*Southern California Edison Company*

Subject: Docket No. 50-206  
Masonry Wall Test Program  
San Onofre Nuclear Generating Station  
Unit 1

DETAIL AT EL 42'-0"

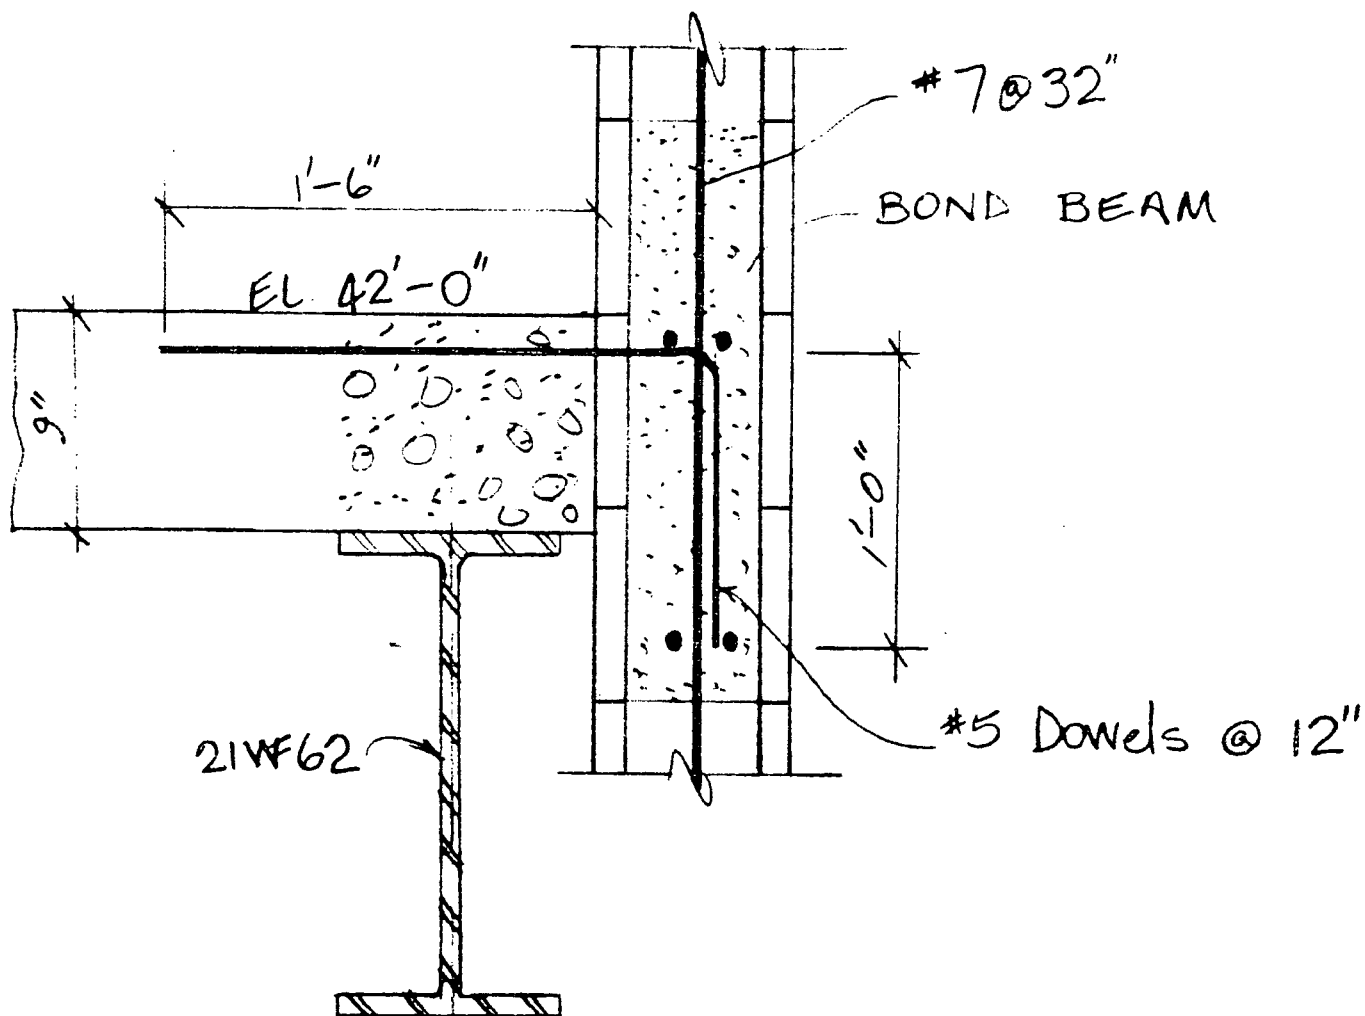
The NRC asked for an assessment of the effects of the connection of the 480V Switchgear Room walls in the Fuel Storage Building on the test program and the wall evaluation.

Around the switchgear room the masonry walls have a total height of 52 feet, from Elevation 14'-0" to the roof at Elevation 66'-0". These walls are structurally connected to the steel members of the floor at Elevation 31'0" and the concrete slab at Elevation 42'-0". This provides a 3 span continuous wall with span heights (from the base) of 17 feet, 11 feet and 24 feet. The uppermost span was that selected for testing both because it was the largest span and also because it had the highest level of input motion.

The connection at the base of this span (Elevation 42'-0") is as shown on the attached sketch. The vertical reinforcing (#7 @ 32") is continuous past the diaphragm and the wall is dowelled into the slab by #5 dowels at 12" centers. This is in fact a "better" connection than that used in the test walls, which was based on the condition of the majority of the Fuel Storage Building masonry walls which are supported on the Fuel Pool concrete slab at Elevation 42'-0". These latter masonry walls had #5 dowels at 16" o.c. rather than continuous reinforcing and #5 dowels at 12" centers tied to the concrete slab. Therefore, the continuous walls are likely to have better moment capacity where they are continuous than the dowelled test specimens.

For the wall evaluation it was assumed that a plastic hinge could develop at Elevations 42'-0" and 31'-0" based on the continuity of the rebar. The maximum reaction loads from the analysis were used to assess the adequacy of the dowels and connections at these levels. This assessment was included in the results of the evaluation.
